PERMIT APPLICATION

18150 Sun Drop Rd
Md. Bldg. Wd. 21771

1 story Single Family Home
on slab, 2 Bedrooms, 1 Bath

Howard County Health Department

" LOT 1 - STANG PROPERTY " PLAT NO. 9185

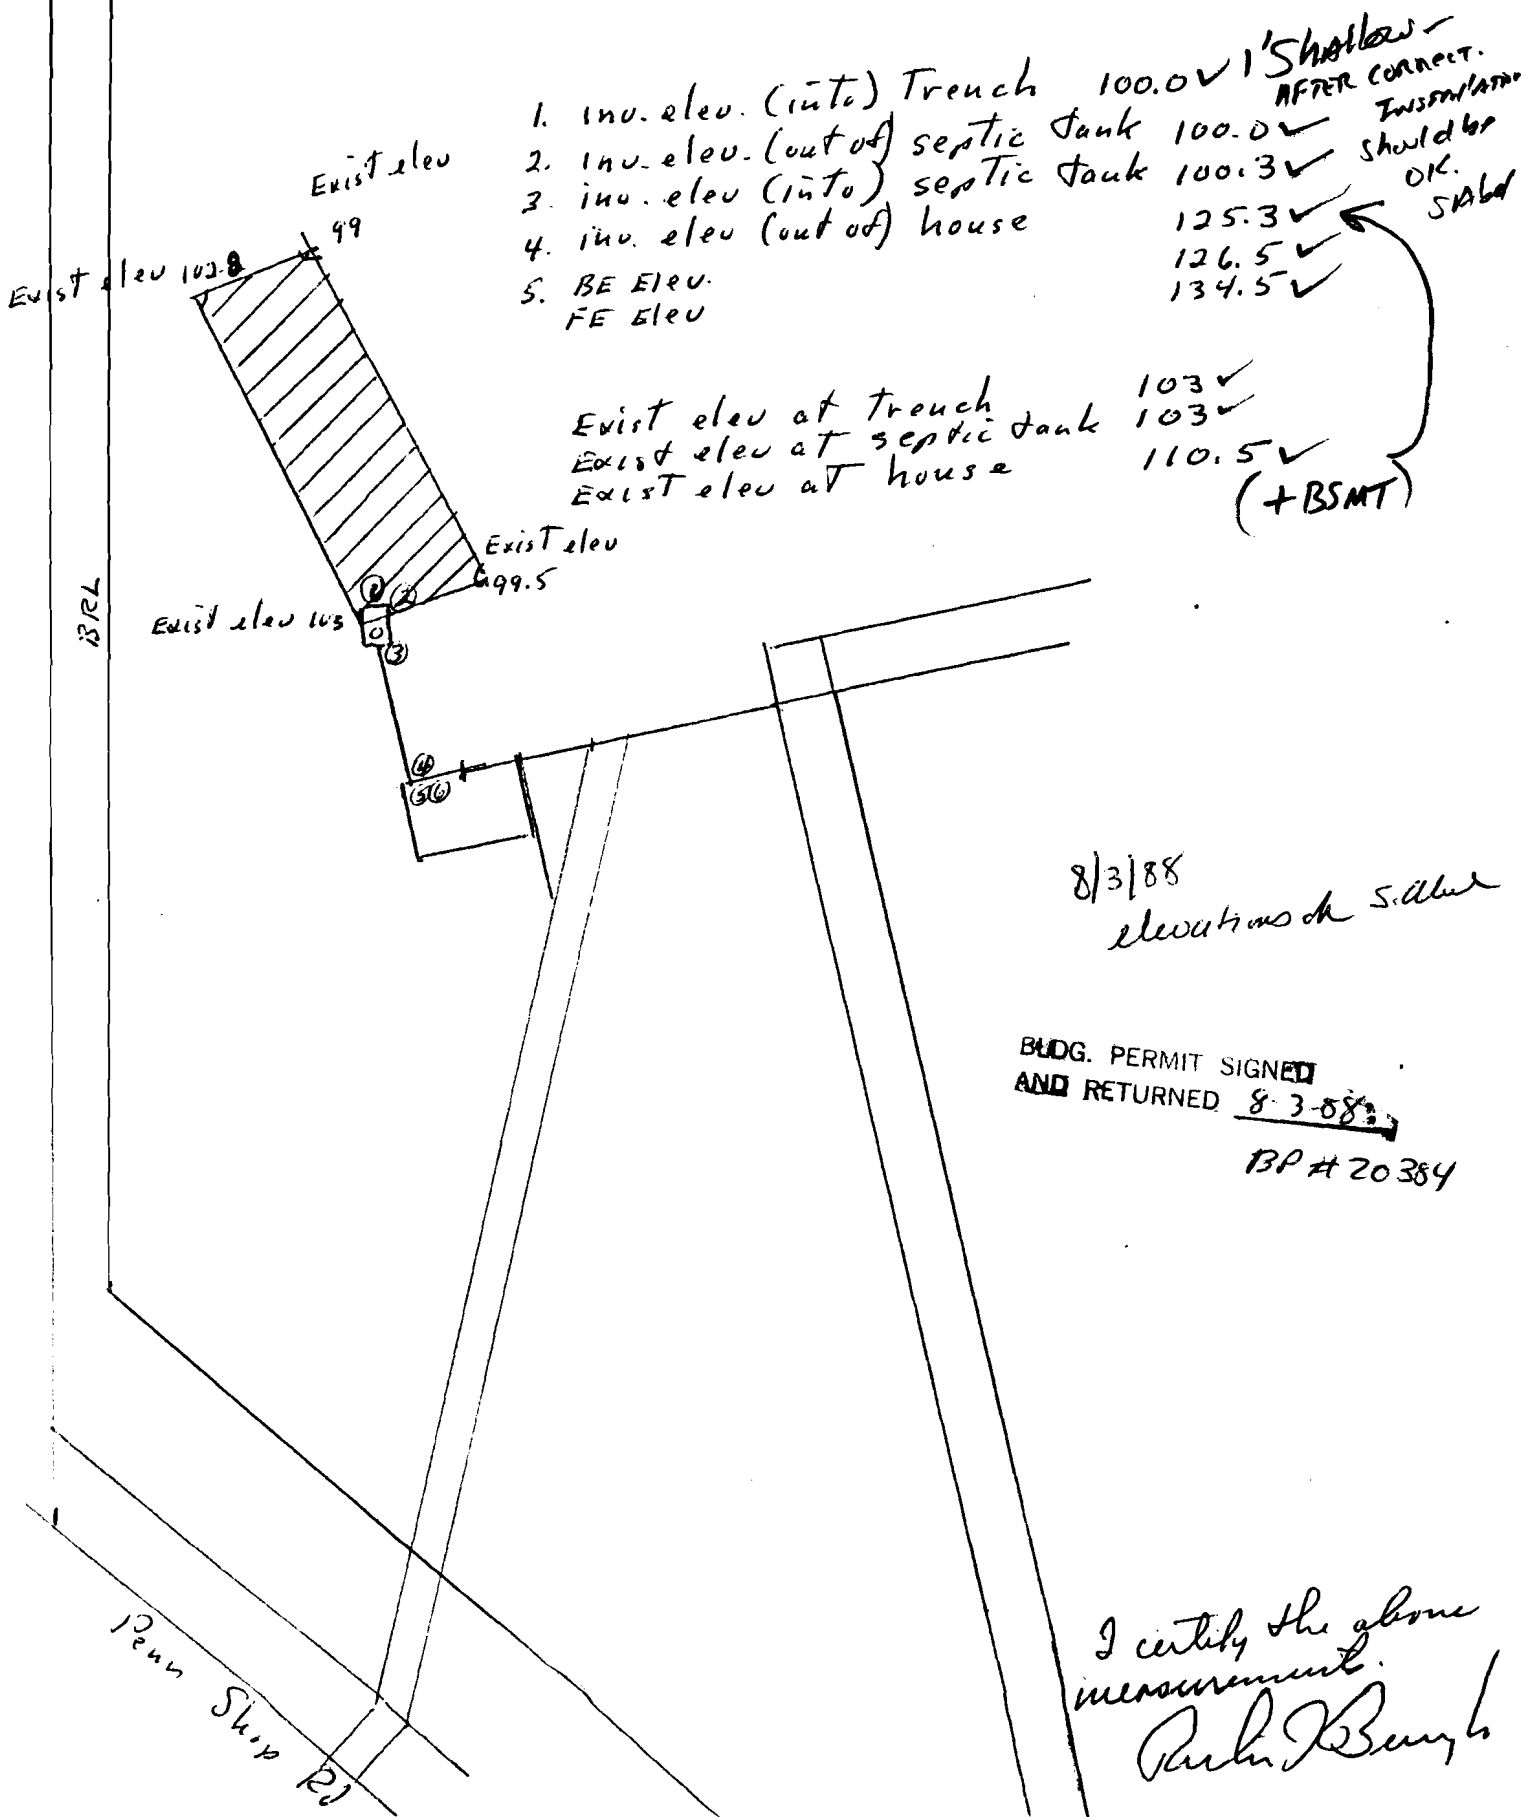
1. inv. elev. (into) Trench 100.0 ✓ 1' Shallow - AFTER CORRECT. INSULATION
2. inv. elev. (out of) septic tank 100.0 ✓
3. inv. elev (into) septic tank 100.3 ✓ Should be OK.
4. inv. elev (out of) house 125.3 ✓
5. BE ELEV. 126.5 ✓
- FE ELEV 134.5 ✓

Exist elev at Trench 103 ✓
 Exist elev at septic tank 103 ✓
 Exist elev at house 110.5 ✓
 (+BSMT)

- DISTANCES: HOUSE TO TANK?
HOUSE TO SDA?
- ELEVATIONS FOR S.S. INCORRECT
- ~~LETTER REQUESTED~~ WELL
WAS DRILLED FOR FARM USE
CHECK W/ MR ON PROCEDURES

8/3/88
 elevations ok S. Allen

REFINE ELEU DRAWING
OK (SEATTLE PLANS)
